## Proposed Burlington Quarry Expansion JART COMMENT SUMMARY TABLE – Visual Impact Assessment

Please accept the following as feedback from the Burlington Quarry Joint Agency Review Team (JART). Fully addressing each comment below will help expedite the potential for resolutions of the consolidated JART objections and individual agency objections. **Additional, new comments may be provided once a response has been prepared to the comments raised below and additional information provided.**

Photo 50: Approx. 2322-2402 2 Side Road. Facing Towards Proposed Southern Extension.

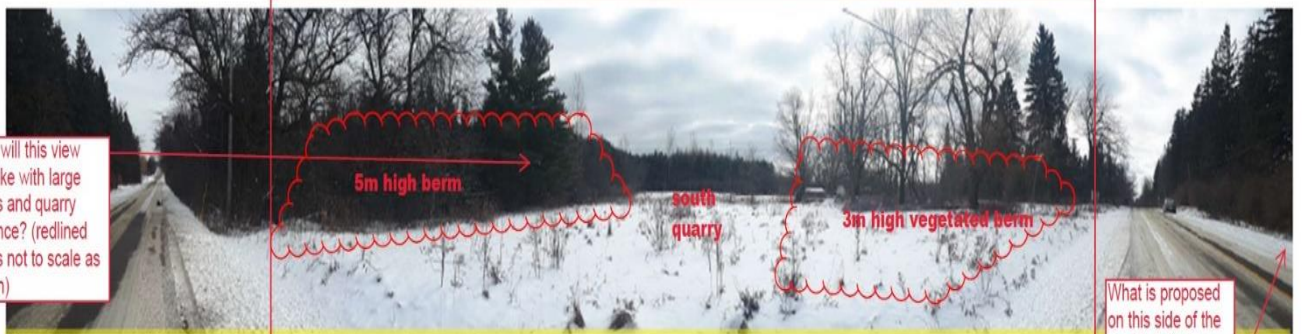
What will this view look like with loss of open view and proposed berming?

What will this view look like with large berms and quarry entrance? (redlined berms not to scale as shown)

What is proposed on this side of the road? Is there a crossing here? Vegetation/berm removal?

Figure 5B

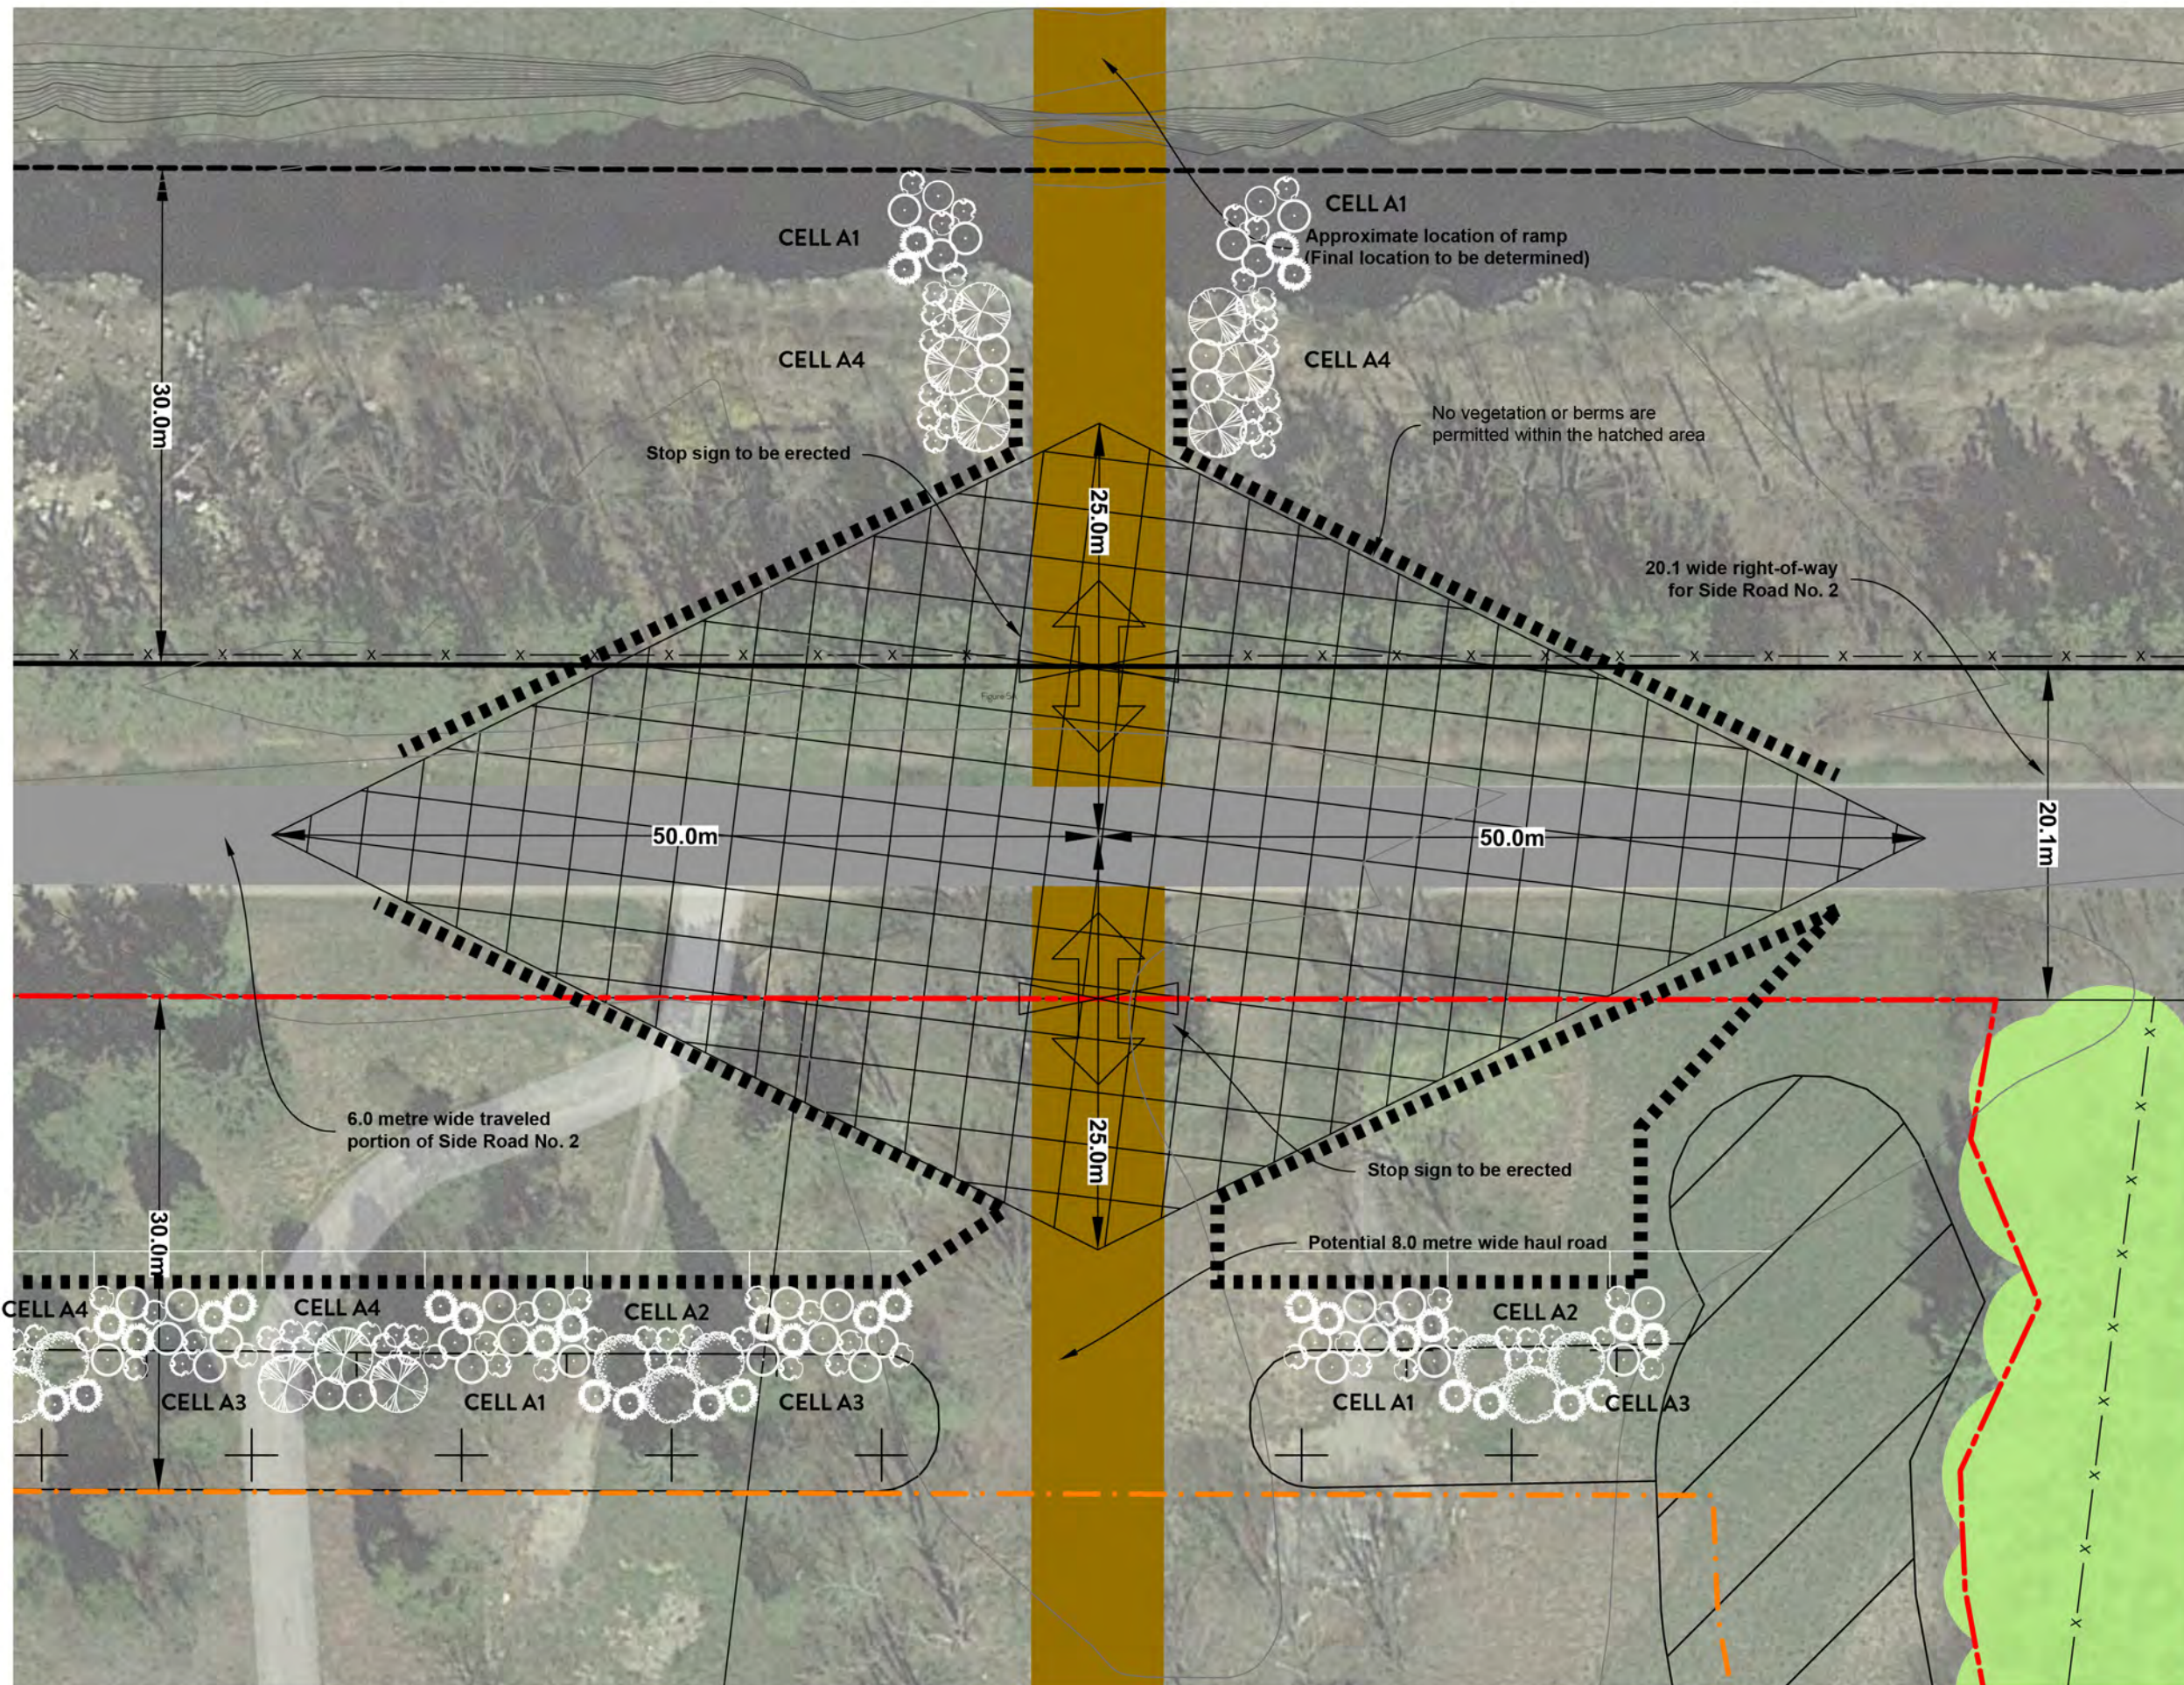
<p>The VIA refers to an at-grade crossing on Sideroad 2 for the purposes of processing (in Section 4.0) but there is no information provided on what work will be undertaken on the north side of the road to accommodate this crossing. Visual impacts related to the construction of an intersection at this location, including the removal of berm and vegetation on the north side of the road have not been assessed. Further information on the proposed crossing and associated visual impacts is required. Additional photography and photo simulations should be provided for both the north and south side, and amelioration of the visual impact on the southern entrance to the south extension by gradation of berms.</p> <p>There is some lack of clarity in the Planning Justification Report and inconsistency between the PJR and the Traffic Study (2020 and 2021). The Traffic study recommends a crossing of No. 2 Side Road from the south extension to the north side of the road for processing (2020: pages 35, 38). The Planning Justification Report makes similar statements that aggregate from South Extension Phases 1 &amp; 2) will be transported by this crossing, but also makes ambiguous statements (pages 1, 11, Figure 3) that “the extracted aggregate will be transported to the existing Burlington Quarry for processing and shipping to market utilizing the existing entrance/exit...”.This matter needs clarification by the provision of details in the VIA and Site Plan of the work proposed on the north side of No. 2 Sideroad.</p>	<p>Section 7.4 and Figure 5B have been added to the report. This section deals with how the at grade crossing will be treated. It is emphasized that views into the quarry will be limited to being directly in front of the vehicular crossing and is not considered to be of significant impact to the larger open landscape character of the area.</p> <p>See updated report dated May 2022.</p>
